LAND USE

The project site is materially inappropriate in its size, shape and location. This inappropriate site selection drives a higher trade off in land use.

Figure 4-1 Solar irradiance levels per day Source: (NASA, 2009)

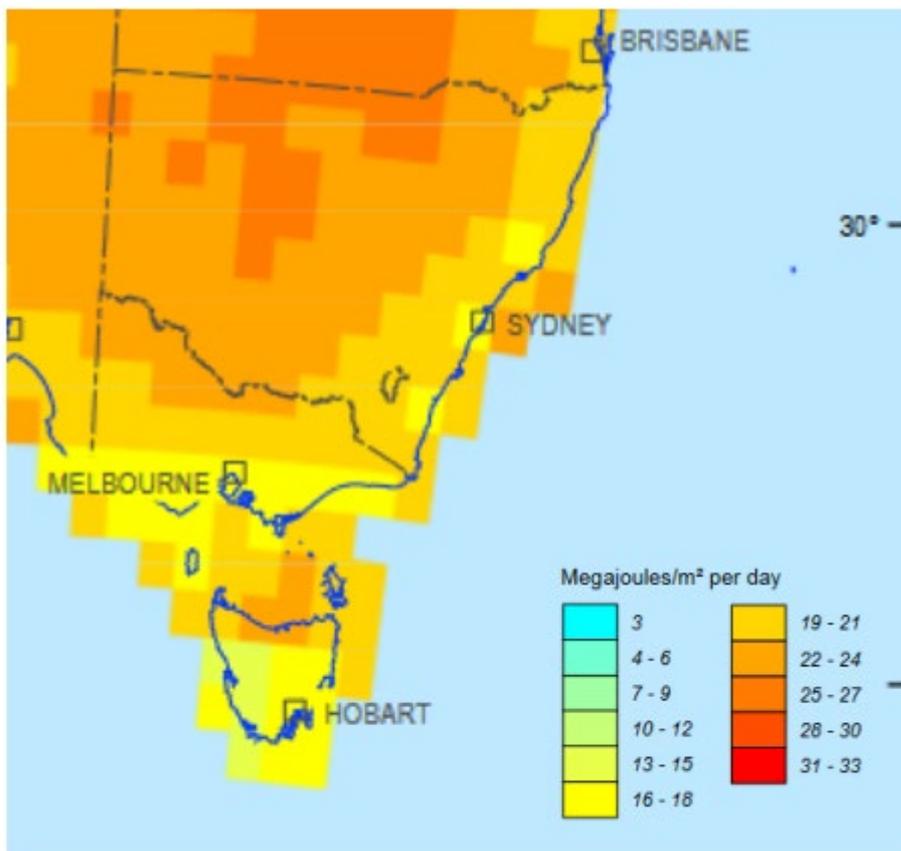
Elgin justify the site selection as it provides a “High quality solar resource”. There is no evidence to support this assertion, as Elgin has not conducted an actual irradiance study at the site (despite having access for 3 years), and this site has poor solar irradiance when compared to other sites across western NSW.

Elgin based their site selection on a high level NASA report (see below), this indicates that no site based or local analysis was performance. There are numerous alternative sites with lower risks and impacts, and better solar irradiance.

Figure 3. Suitable locations for solar development

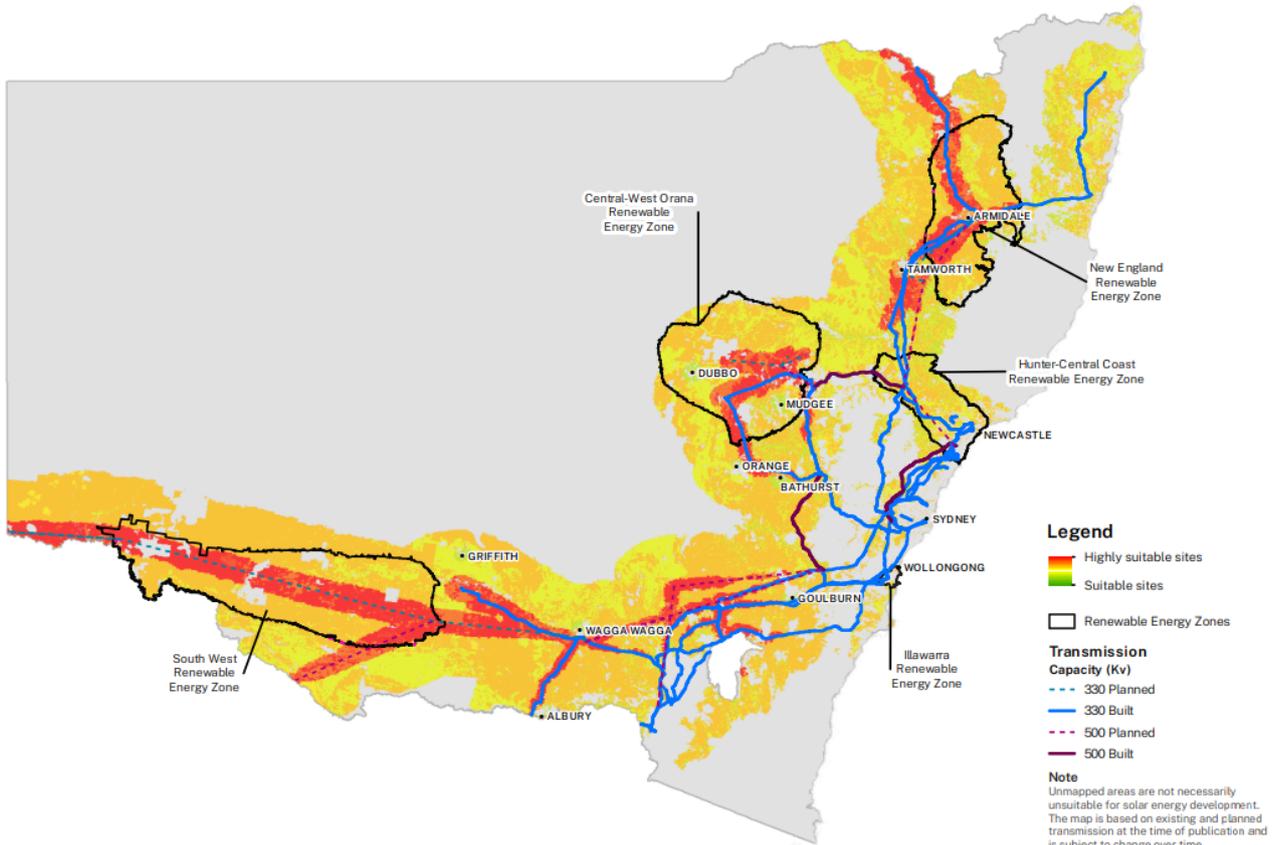
DPE's suitable sites from their Draft Energy Policy Framework (Nov 2023), **indicate that this site is not mapped suitable** (as its within 5km of land zoned residential for a Regional City and not near transmission lines and is surrounded by land mapped as "less suitable"). I believe this map also debunks Elgin's reason for being within the 5kms and not in a REZ, as its not close to either planned or built 330 or 500 KVA transmission lines.

Fig. 8. Air temperature difference as a function of distance from the perimeter of the solar farm. Negative distances indicate locations within the solar farm.

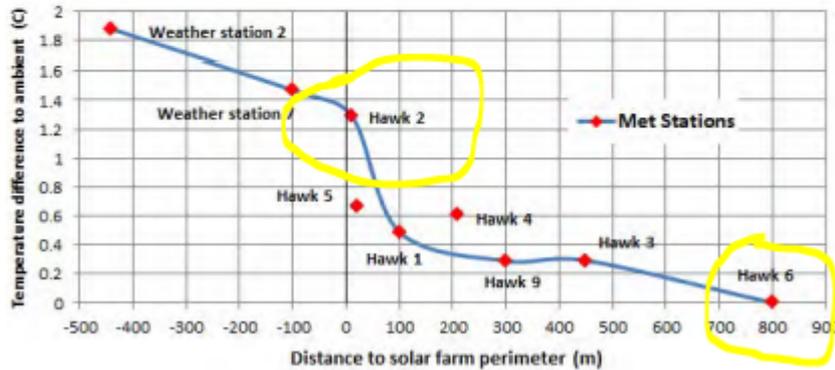
I.e., an increase in temperature from ambient of 1.292 °C at 10m from the solar farm perimeter, with the air temperatures increase of 0.289 °C at 300 m, 0.292 °C at 450 m, dissipating to ~ 0 oC at 800 m from the perimeter.

neighbouring crops and impede farming operations. **Their current site plan should allow for a 800m buffer**, aligned to the scientific results of Fthenakis and Yu. Any change from a 800m buffer during the life of the project should be scientific and evidence based.
